Sheet No. C0.0

Project Title:
EAST TOWN CROSSING PHASE 1

Project No.
2230752
Issue Set & Date:
PERMIT SUBMITTAL
11/20/2023

Sheet No.
C4.31
40 of 63 Sheets

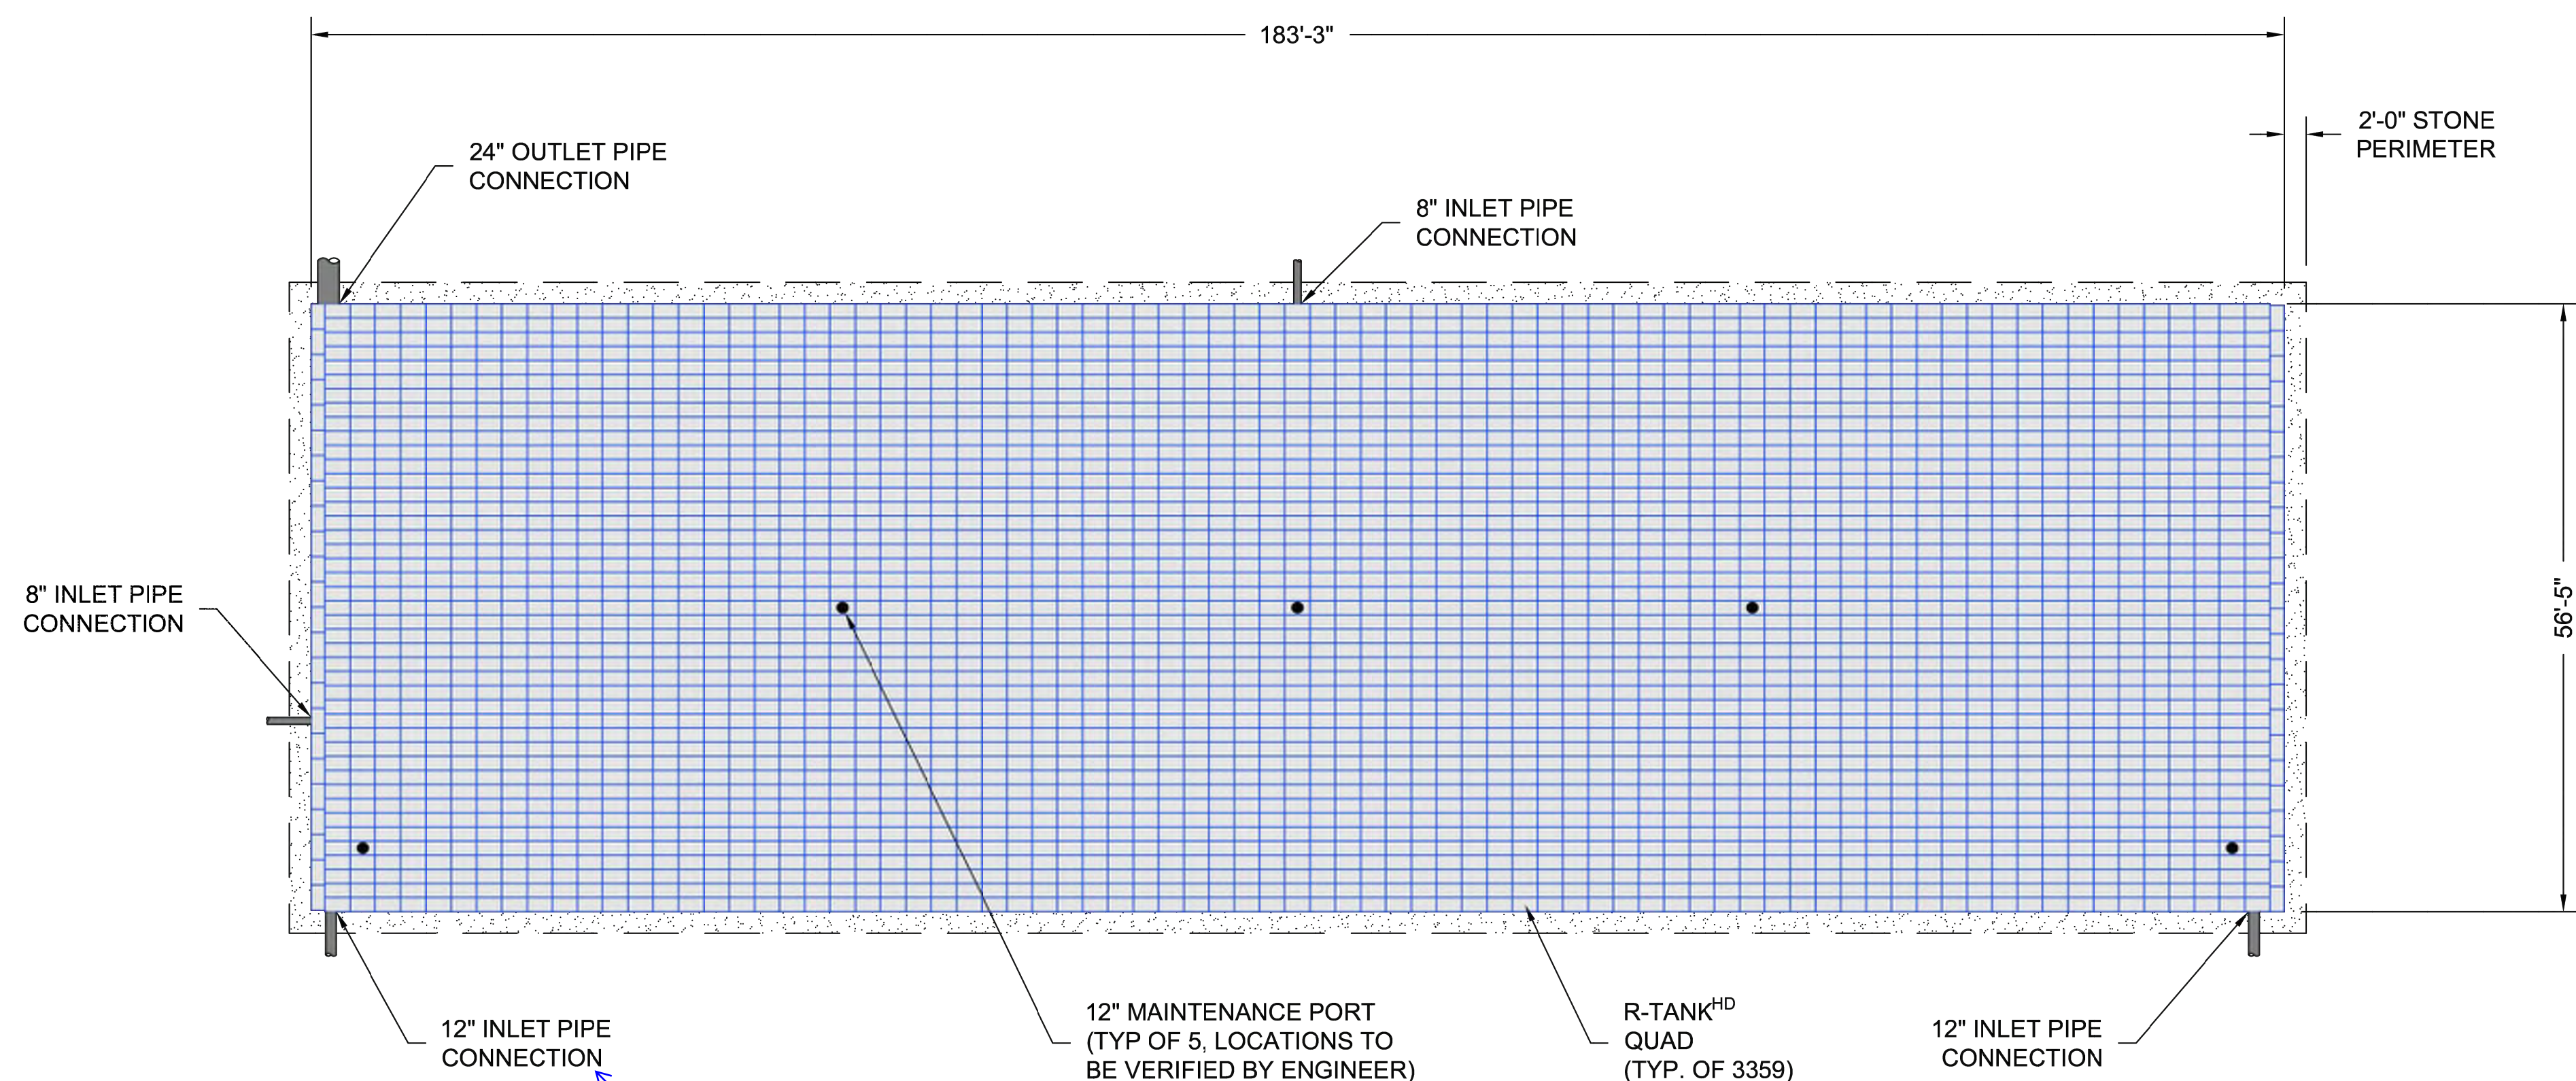
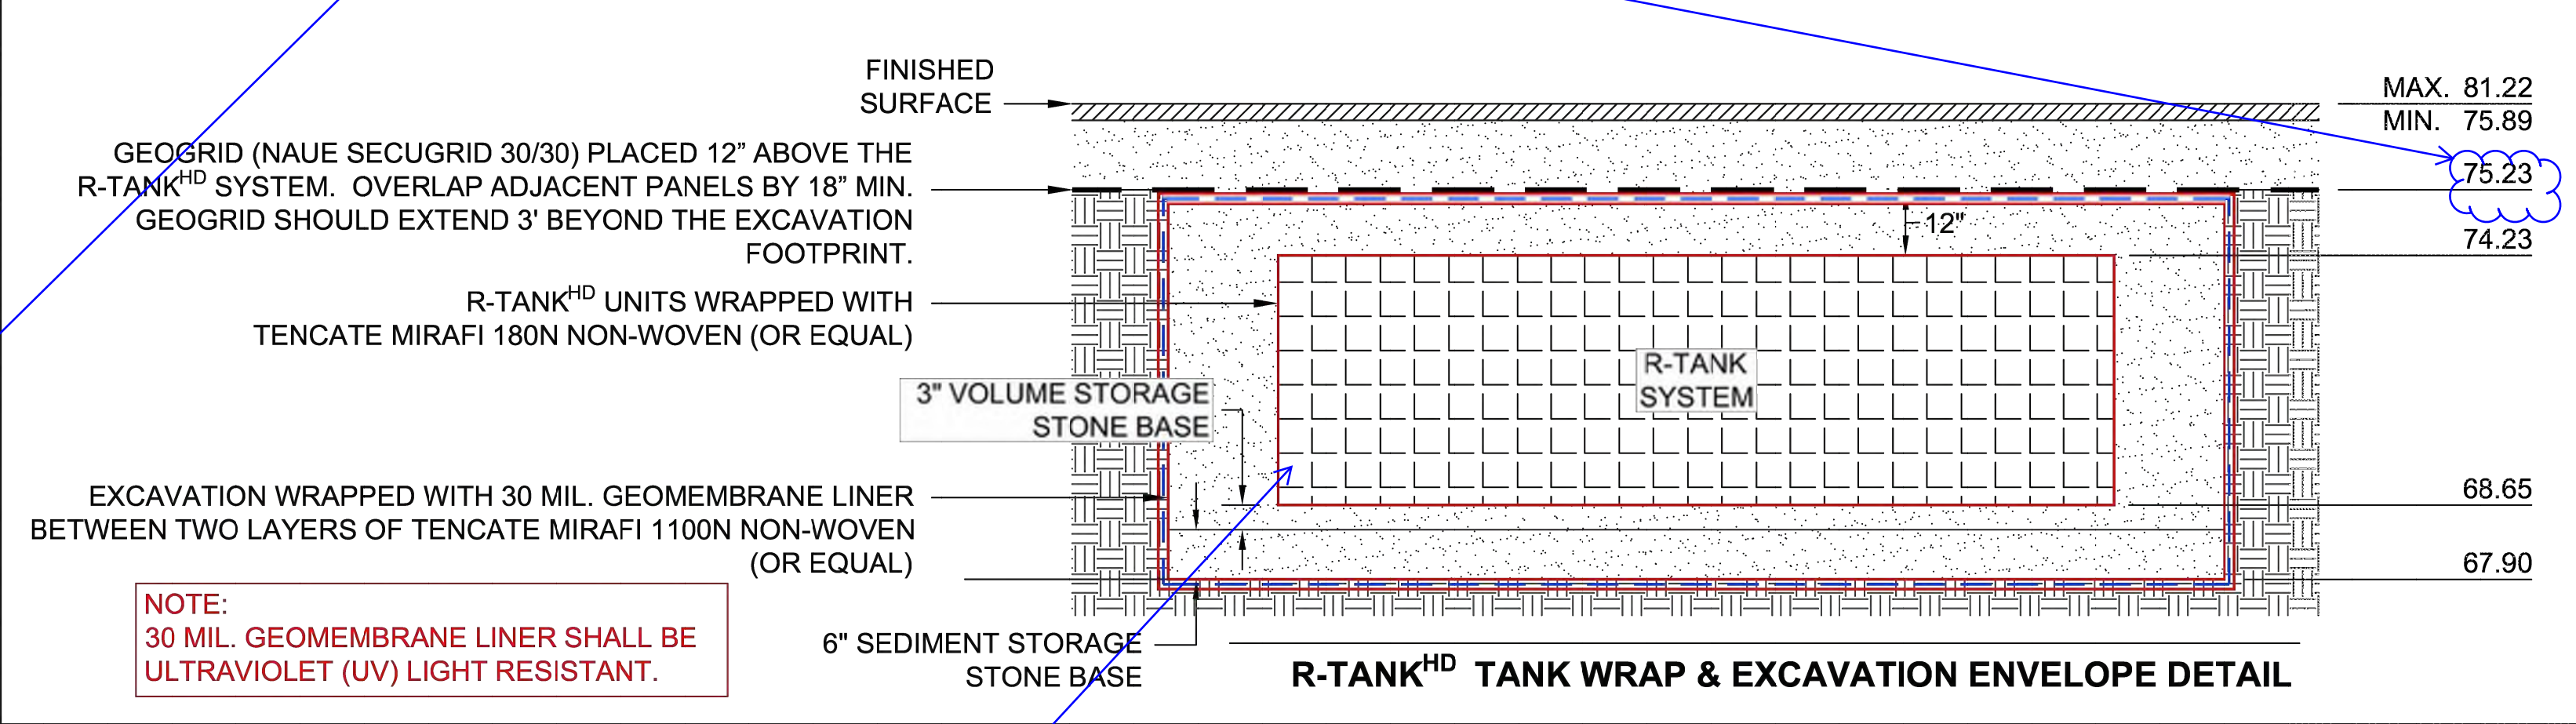
Clarified in report
CLARIFY: See storage volume required
comments in Storm Report, Pg 372 of 448.
[Plans Sht C4.31; Pg 40 of 63]

COORDINATE with Sht C4.04
[Plans Sht C4.31; Pg 40 of 63]
Revised to 24"

Clarified in report
CLARIFY: See Control Structure comments on Sht C4.07,
and riser comments in Storm Report, Pg 372 of 448.
[Plans Sht C4.31; Pg 40 of 63]

Provided
PROVIDE 2-yr and 10-yr water surface
elevations on the cross section.
[Plans Sht C4.31; Pg 40 of 63]

Sheet No.
C5.01
45 of 63 Sheets

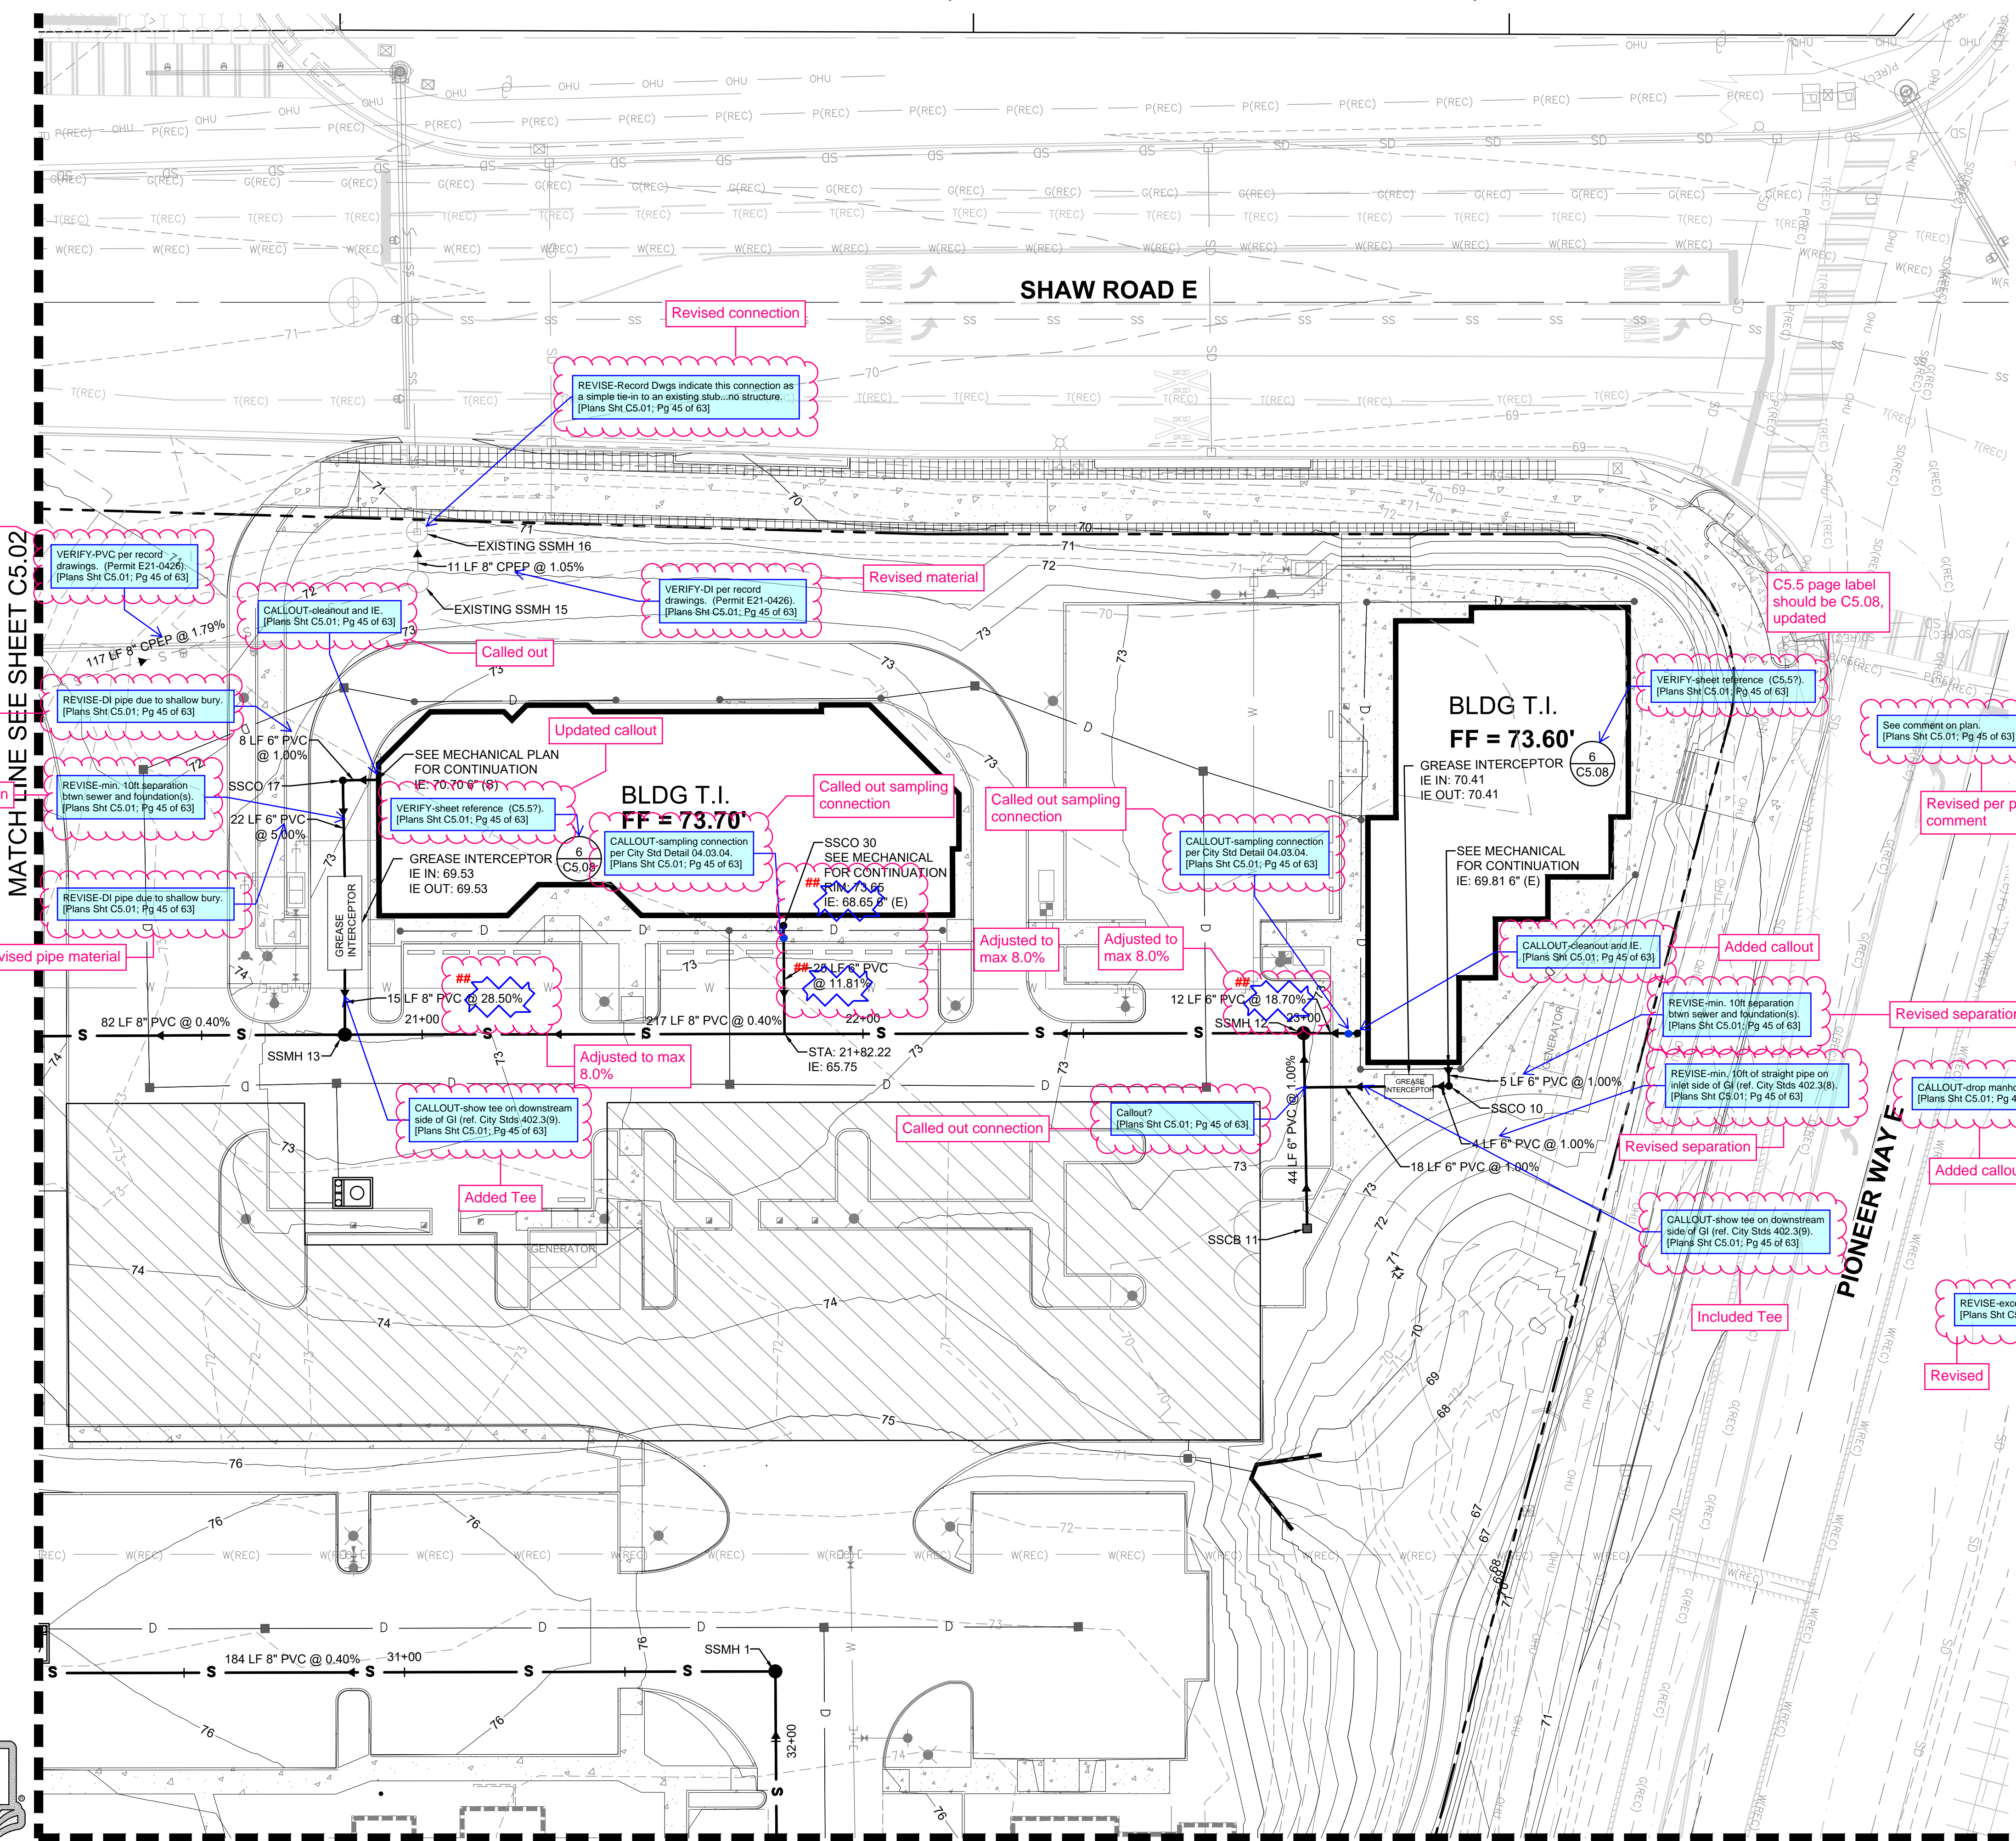
Service lateral exceeds max. grade (8% max). Revise accordingly. [Plans Sht C5.01; Pg 45 of 63] **Noted**

PROVIDE grease interceptor sizing calculations (750 gal min) for both GIs. [Plans Sht C5.01; Pg 45 of 63] **Provided as memo**
